NUMBER: 18-102-22 REV. A

GROUP: 18 - Vehicle Performance

Flash: Powertrain Control Module (PCM) Updates

2020	(DJ)	RAM 2500 Pickup
2020	(D2)	RAM 3500 Pickup

Fig. 1
CP3.3 Design Pump

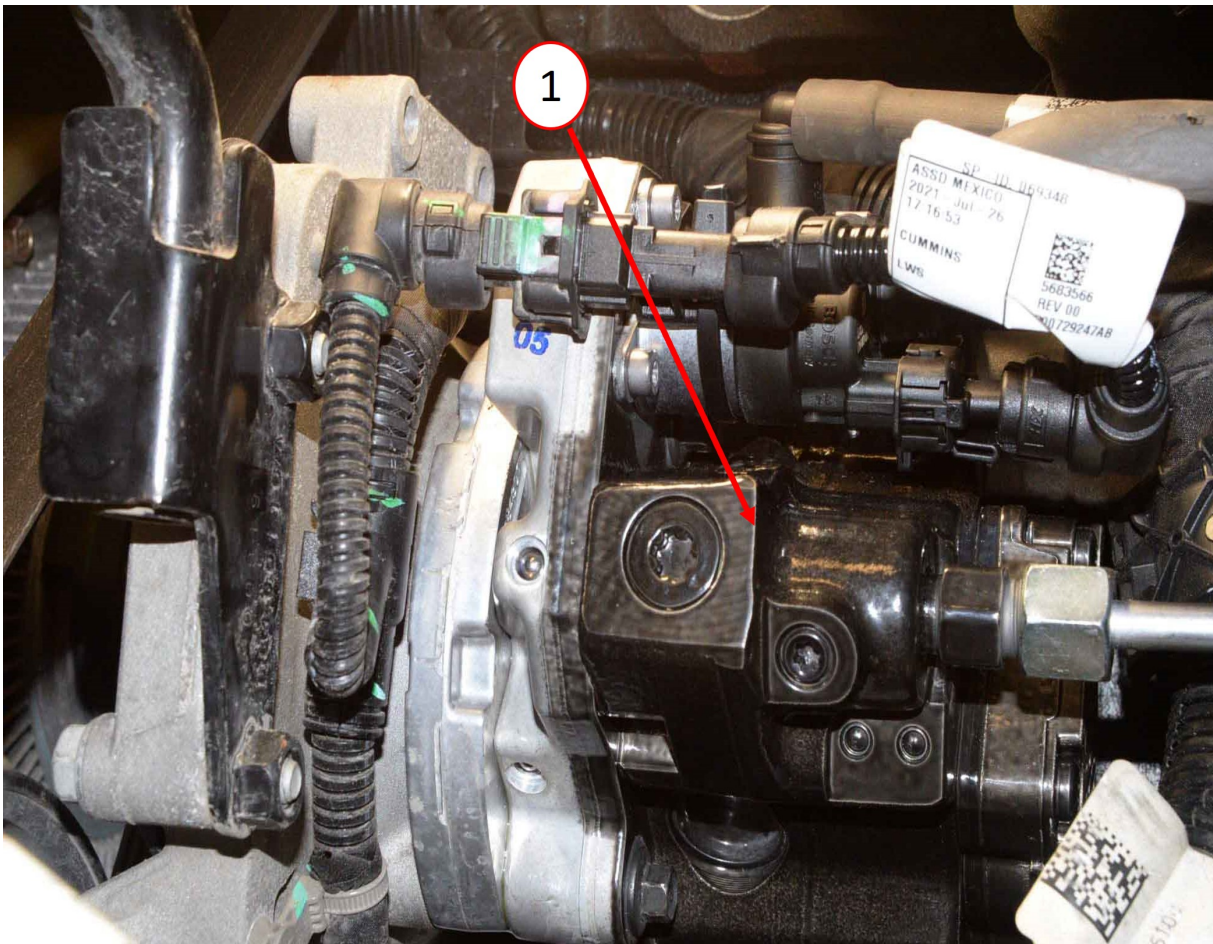
NOTE: The only calibration available will be for the updated CP3.3 design High-Pressure Fuel Injection Pump (Fig. 1) . Please ensure that recall Y78 has been completed first before proceeding with this update.

1. Inspect the High-Pressure Fuel Injection Pump to see which pump is currently installed on the vehicle (Fig. 1) . Also review the vehicle VIP report to see if campaign Y78 has been performed.

2. Does the VIP report indicate that Y78 has been performed, and is the vehicle equipped with the new design fuel injection pump released under the campaign?
 - YES>>> Proceed to [Step 1](#).
 - NO>>> Perform the Y78 campaign first. Once the campaign is performed, new pump installed and PCM updated, the PCM will have all of the updates listed in this document. This Bulletin does not apply.
